ADDENDUM NUMBER 1

Project: USC Union – Central Building

HVAC Upgrades

USC Proj No. H40-9512 / 50003140-4

FIRST FLOOR PLAN — 864

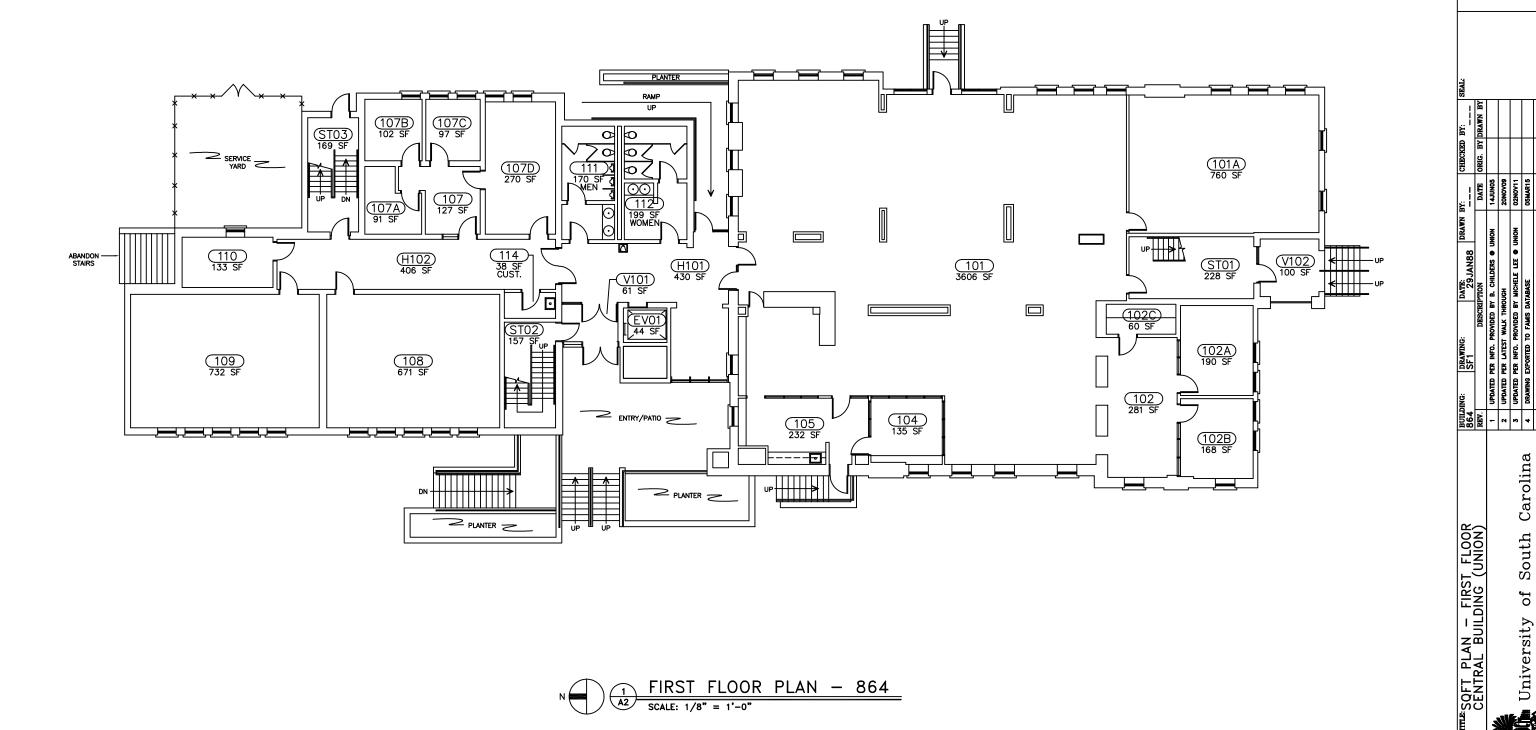
1. Could you confirm square footage for acoustical ceiling demo and replace?

See attached SQFT drawing for additional information. This is provided for reference only. All field verification is the responsibility of the contractor, including any additional quantities required for cutting/patching/install issues and attic stock. Refer to Architectural drawings for scope of work for each space.
